<b>Docket Number:</b>	24-OPT-03
<b>Project Title:</b>	Soda Mountain Solar
<b>TN #:</b>	268995
<b>Document Title:</b>	Response to CEC Email
<b>Description:</b>	This document provides a response to an email from the CEC dated March 5, 2026.
<b>Filer:</b>	Hannah Arkin
<b>Organization:</b>	Resolution Environmental
<b>Submitter Role:</b>	Applicant Representative
<b>Submission Date:</b>	3/11/2026 8:39:30 AM
<b>Docketed Date:</b>	3/11/2026

**From:** Thea Benson  
**Sent:** Tuesday, March 10, 2026 4:24 PM  
**To:** 'Hannah Arkin'; Marlyng Gama  
**Cc:** David Daitch; May Lau; Emily Gaston  
**Subject:** RE: [EXT] Fw: Soda Mountain Data Needs

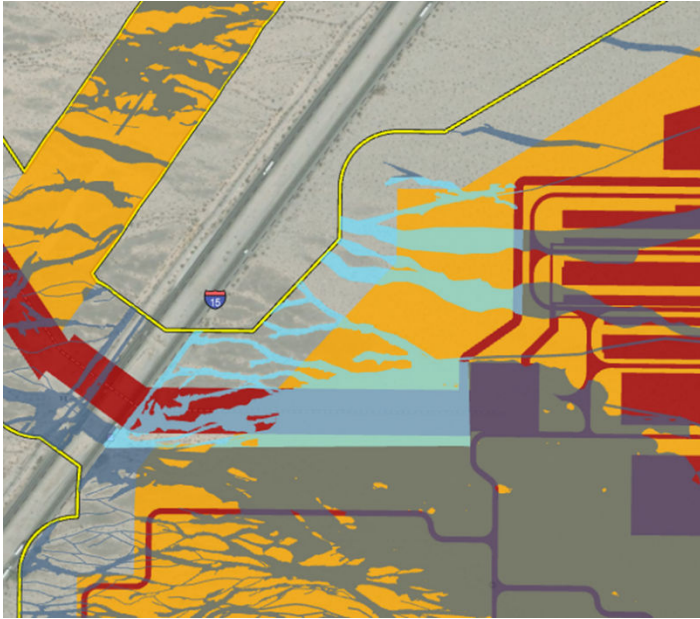
- See below
- Please identify the acres of waters that would be cut off from flow by the construction of the berm and channel. For example, construction of the berm/channel will result in perm impacts to XX acres of and YY acres of temp impacts. In addition, the construction of the berm/channel will reduce surface flow to XXX acres of waters located downstream of the structure.

- A total of 15.2 acres of state waters may be cut off hydrologically downstream of the berm and ditch proposed around the BESS Facility. As shown in the screenshot below, a subset of

the 15.2 acres downstream of the berm and ditch are already accounted for in the total temporary and permanent impact acreages reflected in the table above; however, the 15.2 acres includes the entirety of the downstream waters, including areas outside the direct project impacts. Please see screenshot below highlighting the 15.2 acres downstream of the BESS Facility.
